**CVL Network – CVL Network Code Condition G1 Network Change Proposal:
Cardiff Bay Electrification System (OLE) Commissioning Cardiff Bay to
Butetown**

Appendix A – Proposed scheme for the energisation of the Overhead Line Electrification System (“OLE”) from Cardiff Bay to Butetown Commissioning Event EE3A

Annex 1 Section Diagram for the Energisation of the OLE Bay to Bute Town (Dn only)

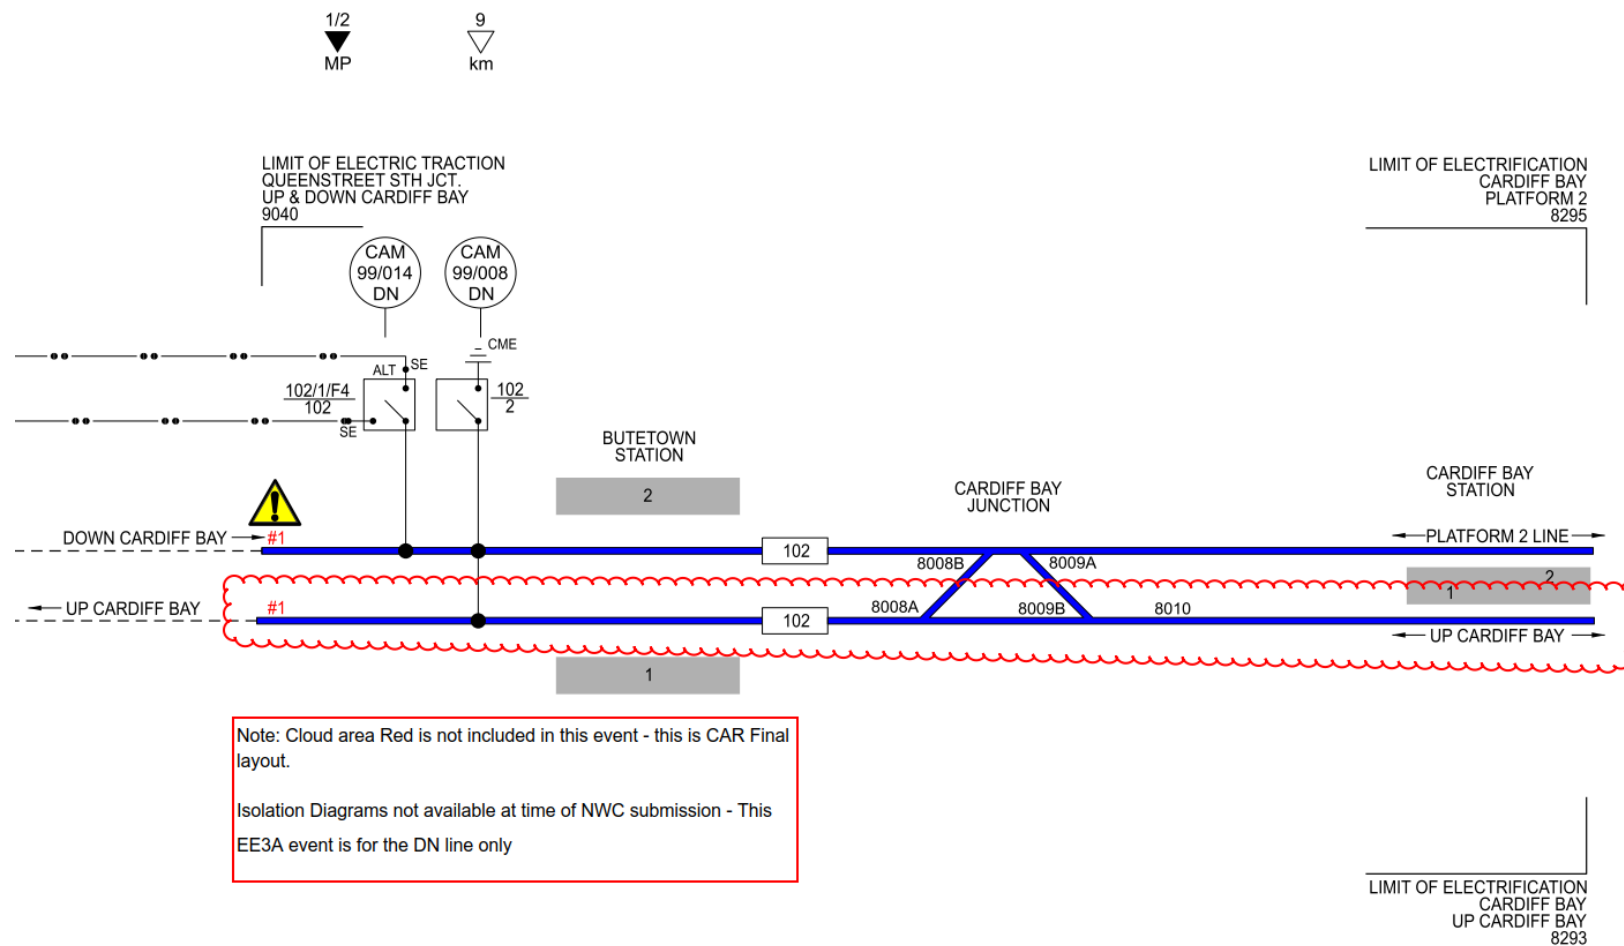
This energisation event will bring into use all 25kV OLE and HV distribution assets from the limit of electrification between Queen Street South Junction through to the end of the Bay Platform Down site only.

This will see the Entry into Service of all new OLE, overhead line switches, HV cabling, and electrical substations as detailed on the Major Feeder Diagram (“MFD”) (TRAN01-PSP-ZZ-CVL-DDR-Y-EP-000003-S1-P04, see Appendix B).

The 25Kv route runs as follows:

CAR 00.325Km Queens MPTSS through to the CAM 99.014km Dn route of 25kV cable

Annex 2 – Sectional Appendix change

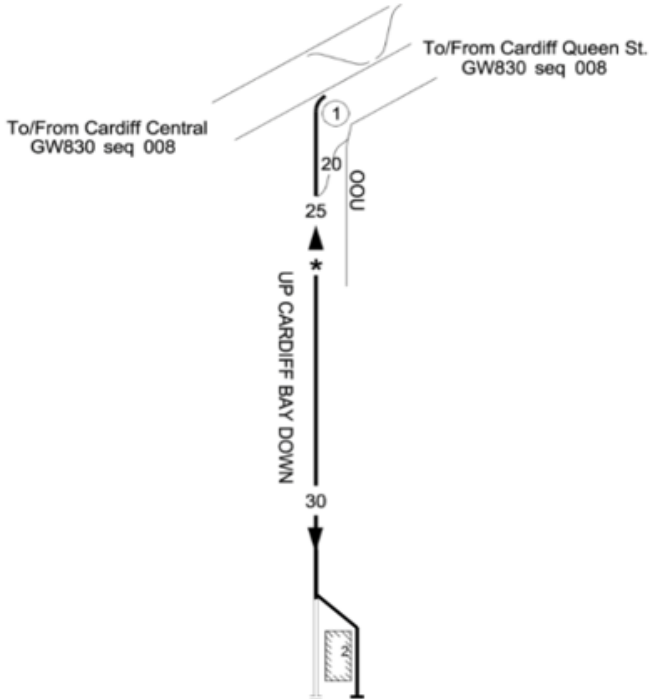
To support the alterations described above, the following revisions will be made to the Western Route Sectional Appendix (March 2025).

The new requirements are shown in **Red** font

LOR	Seq.	Line of Route Description	ELR	Route	Last Updated
GW839	001	Queen St. South Jn to Cardiff Bay	CAM	Wales - TFW CVL	05/03/2024
Location		Mileage M Ch	Running lines & speed restrictions		Signalling & Remarks
Queen Street South Jn		0 66			<p>OT RA6 Wales Rail Operating Centre (Valleys) (CF) AC CVLIC</p> <p>① - Up/Down Cardiff Bay Chord</p> <p>Bay Line electrified</p> <p>Platform 151 metres, 165 yards</p>
Limit of Electrification		0 48 *			
		0 41			
CARDIFF BAY/ BAE CAERDYDD		0 02
